Your Ref: SSD-62802207

**Comments on Hills Showground Precinct East
3 Andalusian Way, Castle Hill (adjacent Hills Showground Metro Station)**

DEVELOPMENT ASSESSMENT PRE-LODGEMENT MEETING NOTES 32/2024/PRE – 1 December 2023

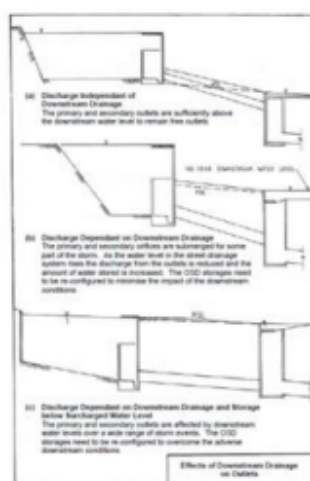
- Submerge outlet will be assessed once the revised civil/stormwater plans are received. However, it appears that the OSD is impacted by "Effects of Downstream Drainage on Outlets" which is not supported. The OSD configuration shall be redesigned. Please refer to Figure 6.3 of the On-site Stormwater Detention R3, of the Handbook Upper Parramatta River Catchment Trust, and the snapshots below:

Options "B and C" will not be supported, therefore, ensure the depth of the OSD is reduced and Options "B and C" are avoided.

With respect to the above, if the OSD outlet is impacted by drowned/submerge condition then the second column shall be used. Hence, the calculation will need to be revised.
